**Wholesale Electricity Market
Rule Change Proposal Submission Form**

**RC_2010_25 and RC_2010_37 Calculation of the Capacity Value of
Intermittent Generation - Methodology 1 (IMO) and Methodology 2
(Griffin Energy)**

Name:	Brendan Clarke
Phone:	9427 5940
Fax:	9427 4228
Email:	Brendan.Clarke@westernpower.com.au
Organisation:	System Management
Address:	
Date submitted:	21 October 2011

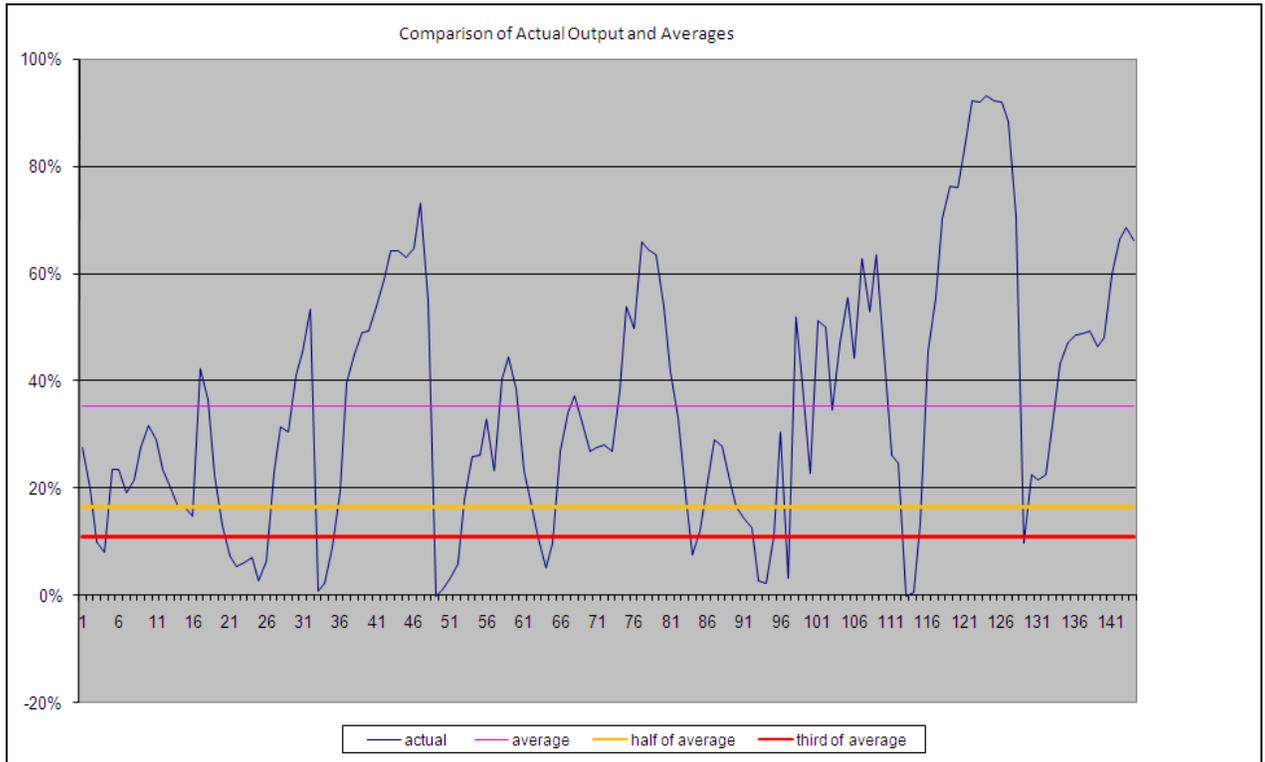
The concept of using average and adjustment values is supported by evidence illustrated in the graph below which compares the actual and average output of all windfarms during 40+ degree days over the past 3 years between 11am and 7 pm 9as a percentage of their installed capacity).

The average output is around 33% of the installed capacity.

System Management's prime concern is the actual output is less than half of the average output (about 16% of the installed capacity) for 17% of the time and the actual output is less than one third of the average output (about 10% of the installed capacity) for 11% of the time.
